Audit of the preconstruction environmental noise assessment – Wimmera Plains Energy Facility (EPA CARMS no.78649-2)

Pre-construction Noise Assessment Audit

Wimmera Plains Energy Facility

Figure 1. Cumulative assessment of noise interference examination (MDA report Appendix I2)

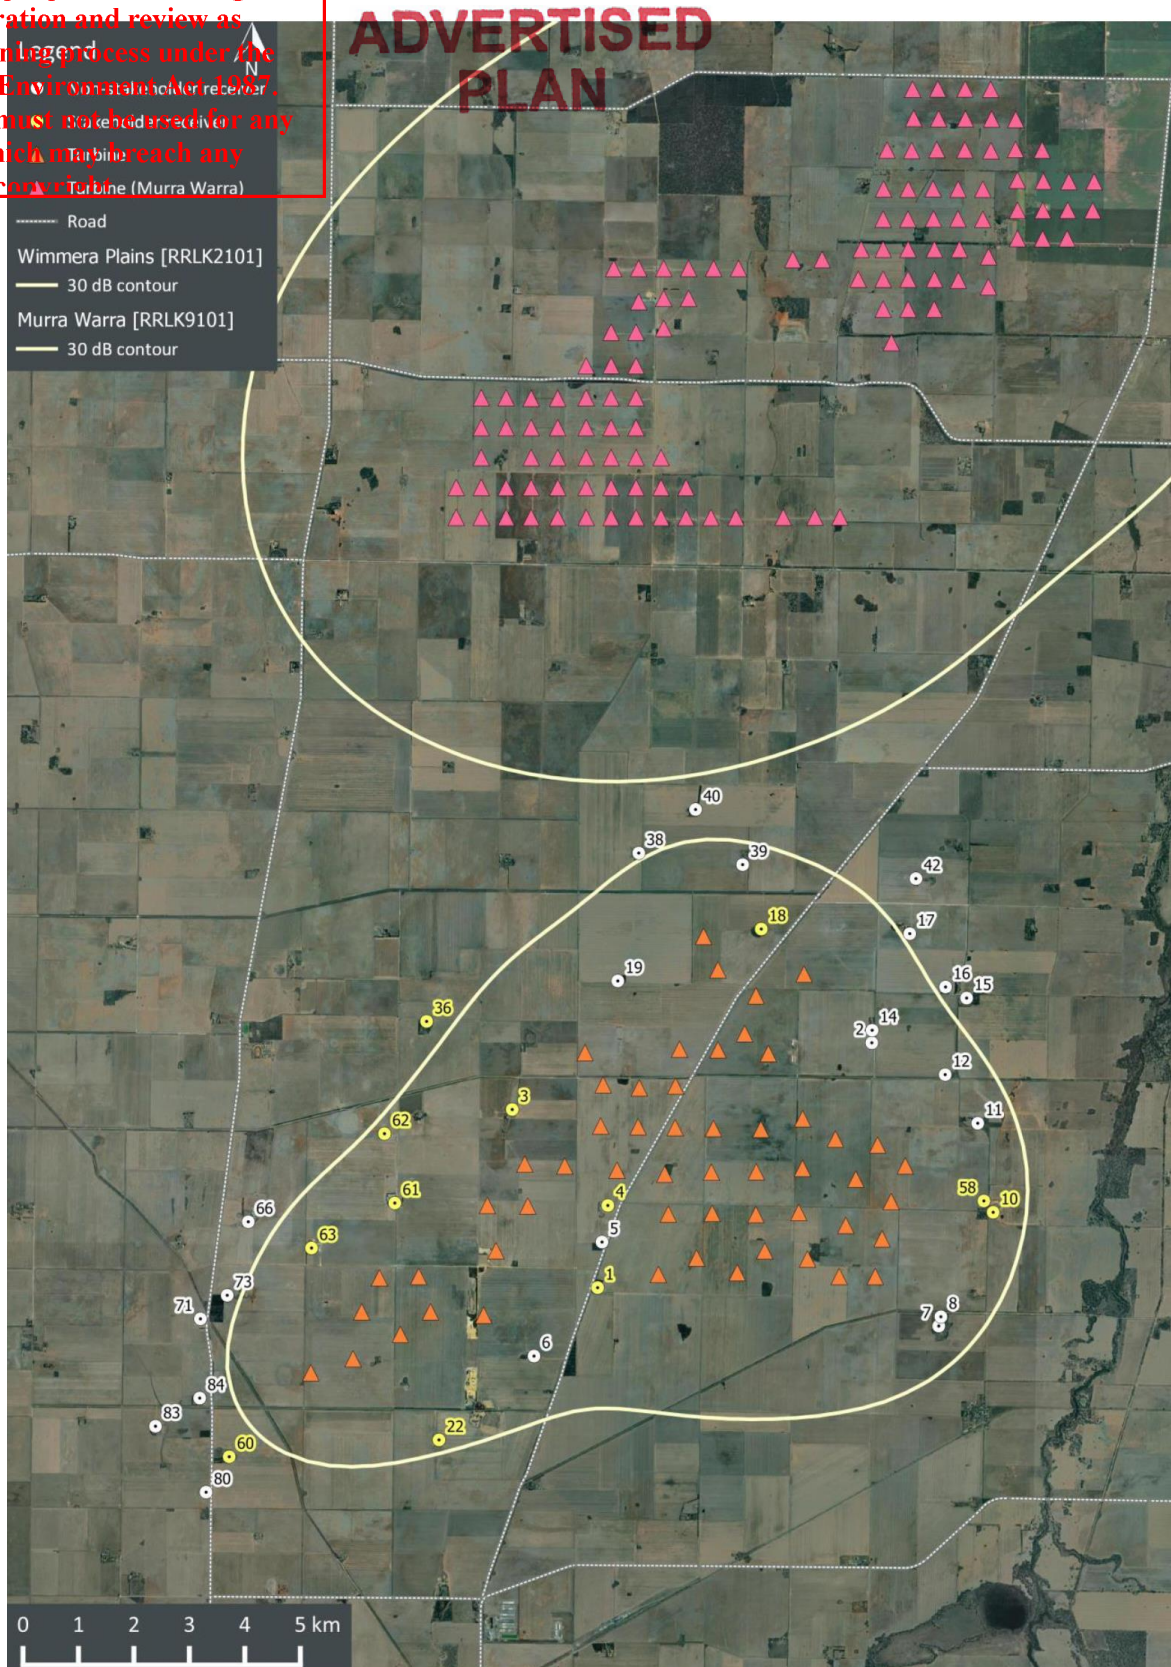
The possibility of competing noise from other wind farm projects was considered in the Marshall Day predictive assessment. The closest operating wind farm is Murra Warra, centered approximately 10 km north of the proposed Wimmera Plains site. The Murra Warra wind farm has completed stage 1 construction of 61 turbines, with another 54 turbines in stage 2 to the north east of stage 1. The predicted noise assessment for the Murra Warra wind farm has a 30 dB maximum noise contour that does not overlap with the predicted 30dB contour of the Wimmera Plains facility. No noise interference between these two wind farms is expected. In stage 2 of Murra Warra the extra turbines are further distant from the Wimmera Plains facility and no significant increase in noise is expected.

Another approved wind farm north of Horsham comprises two turbines at Jung adjacent to the Henty Highway. The Jung wind farm is planned to be located in the proximity of the Wimmera Plains Energy Facility. According to an author of the MDA report the predicted noise impact at the eastern receptors was 25 dB, which produces no measurable negative impact on the receptors.

Figure 2. Predicted noise level contours from the Marshall Day report

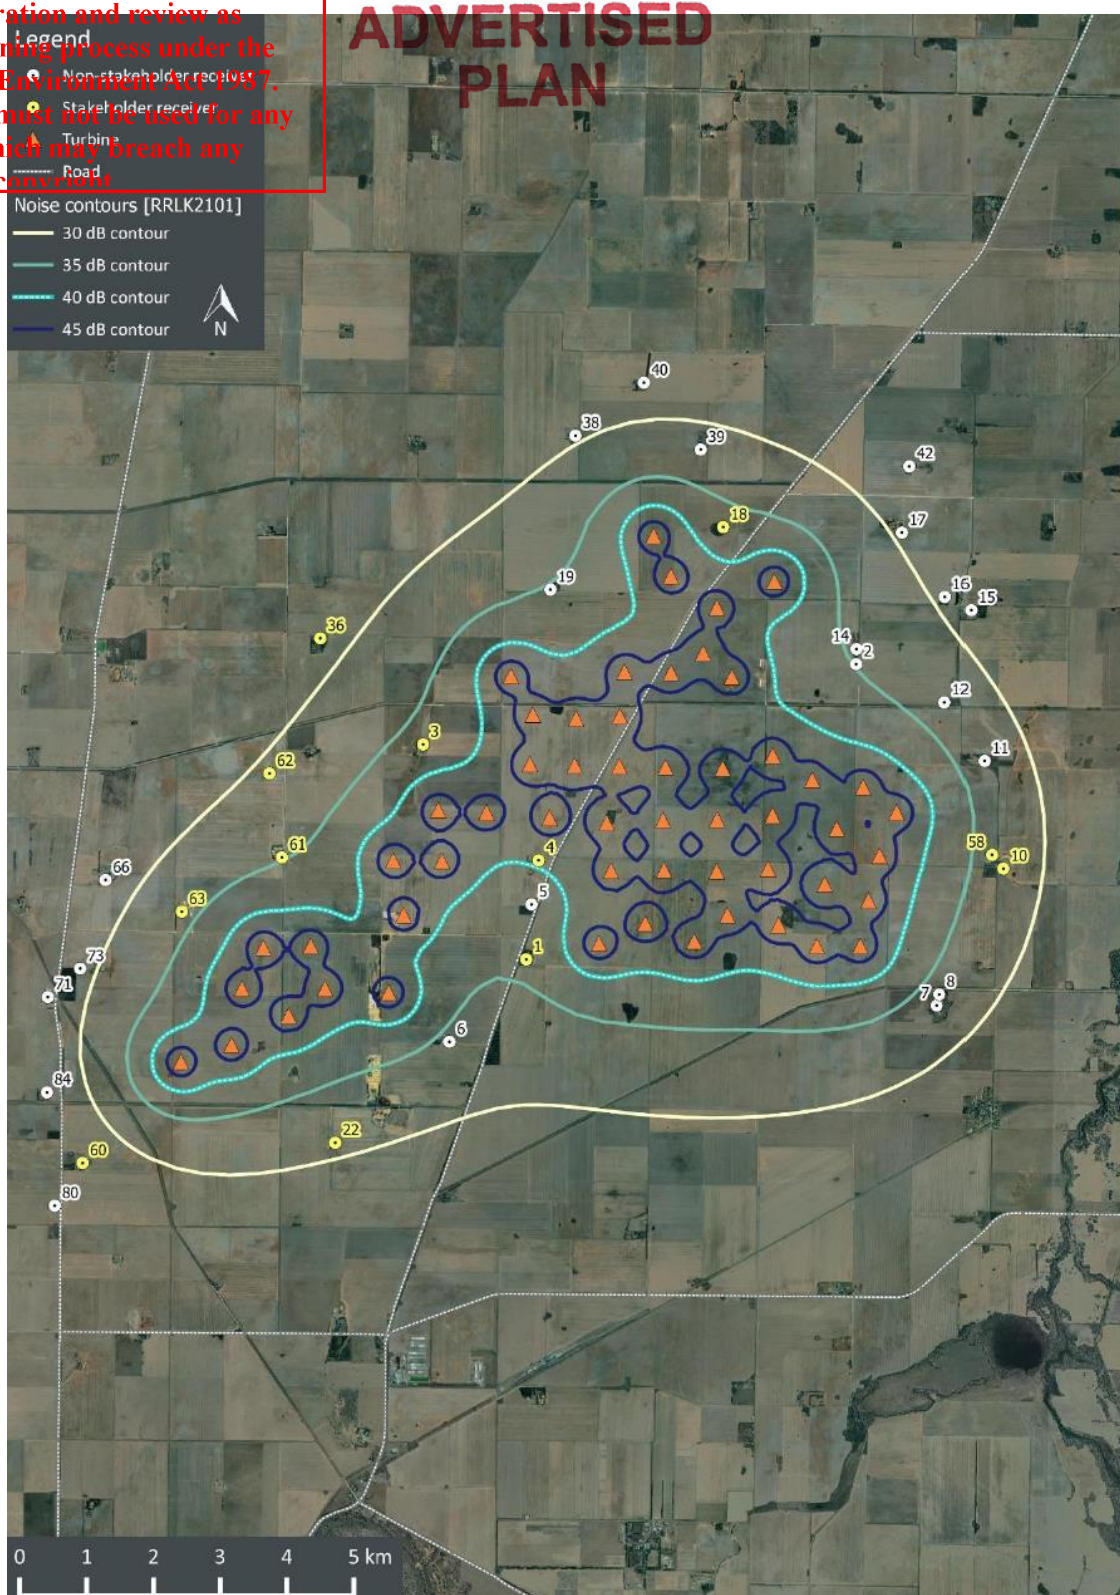
This modelling predicts compliance for the nearest receptors, 5 and 19, while the next two nearest receptors are marginally outside the 35 dB contour, with maximum noise levels of 34.8 dB (Receptor 2) and 34.4 dB (Receptor 14). The Standard states that receptors outside the 35 dB contour are not required to be further considered (sec. 6.1.1).

The two noise sensitive locations involved within the 35 dB contour are Receptor 5 and Receptor 19, both are within the farming zone. Receptor 5 is on the Henty Highway and Receptor 19 is approximately 2 km from the Henty Highway on Shearwoods Road.

Compliance with the Standard will be at issue if either receptor is declared to be in a high amenity area.
